Addendum No. 5

Project: Guilford County Law Enforcement Center Renovation  
Rebid Event # 629

Addendum Date: August 14, 2018

**ADD-5-1**

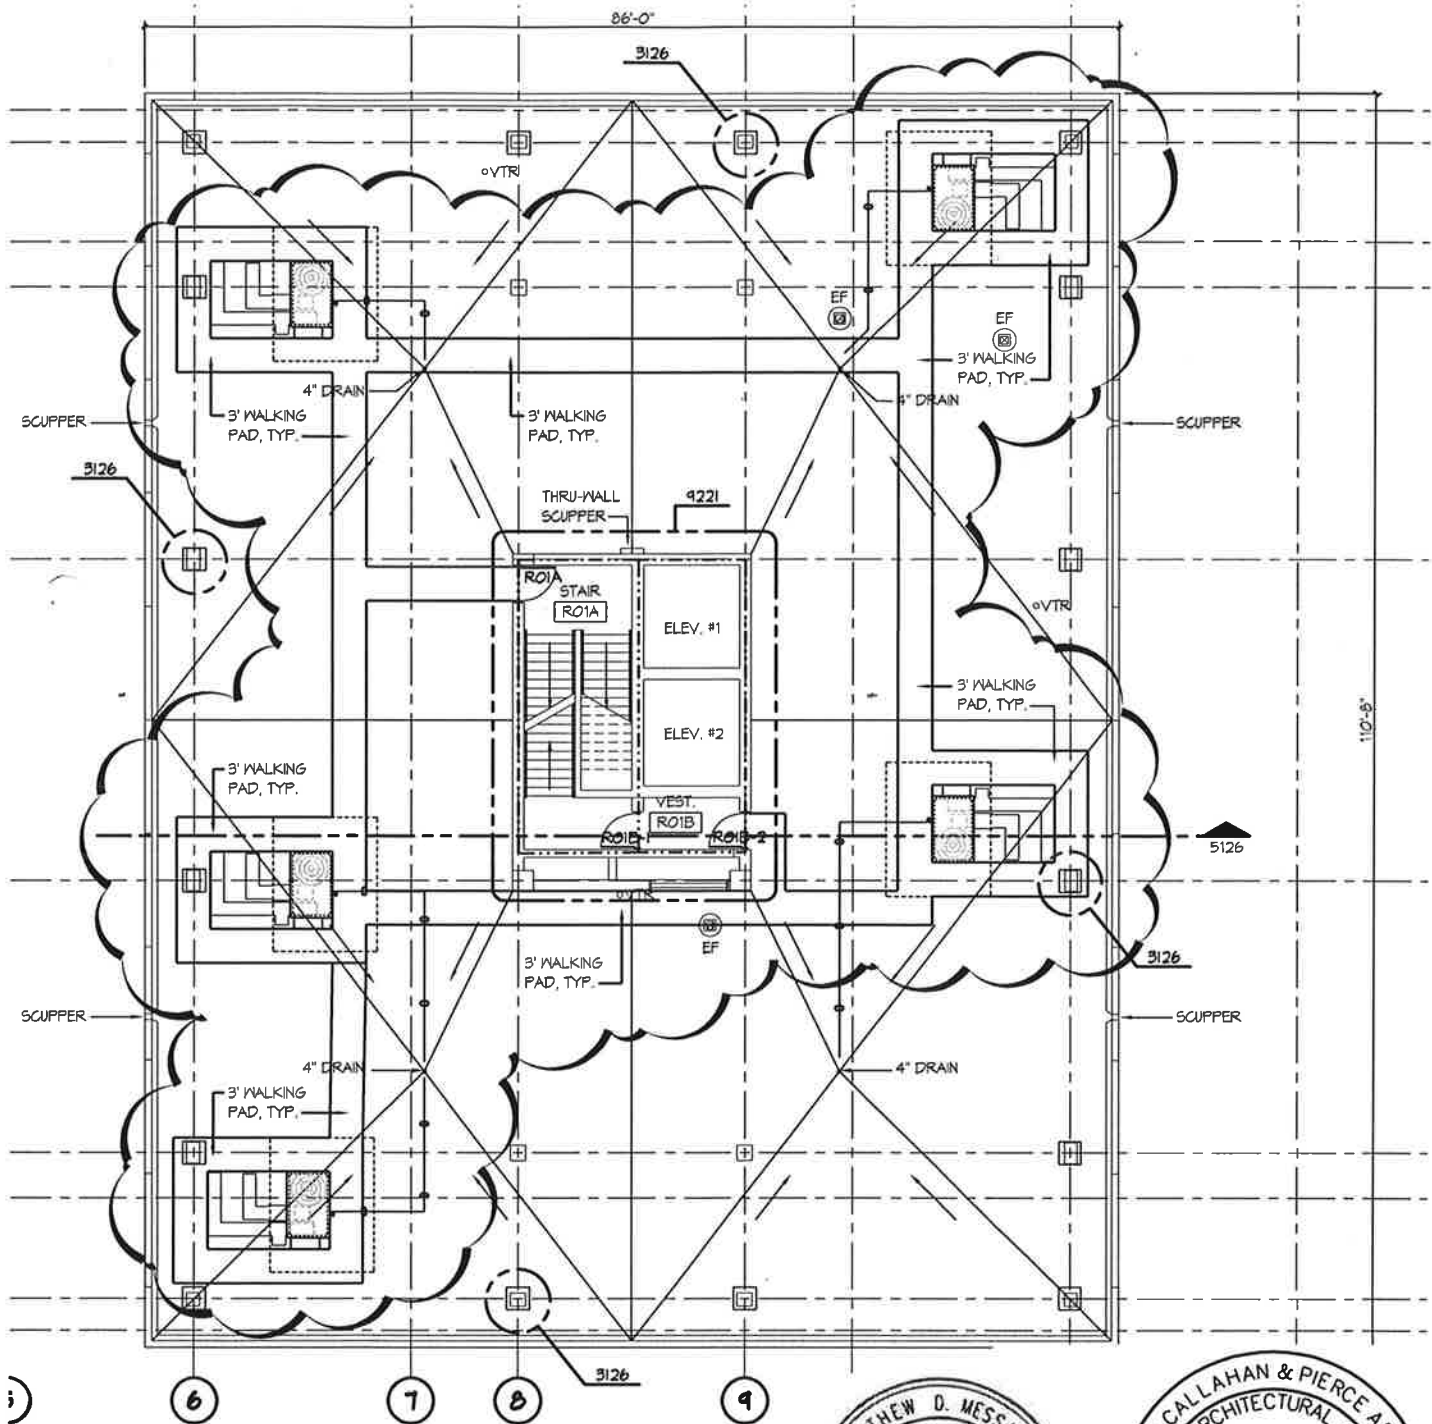
| ITEM | SHEET      | DESCRIPTION                                                                                                                                                                                                                                                                                                                                                                                                                                                         |
|------|------------|---------------------------------------------------------------------------------------------------------------------------------------------------------------------------------------------------------------------------------------------------------------------------------------------------------------------------------------------------------------------------------------------------------------------------------------------------------------------|
| 11.  | A2.2       | 2226 Level 2 – Mechanical – Floor Plan – Roof Plan: Provide roof walkway pads as specified in Section 07 54 00 and as shown on Addendum Drawing ADD 5-1. (Attached)                                                                                                                                                                                                                                                                                                 |
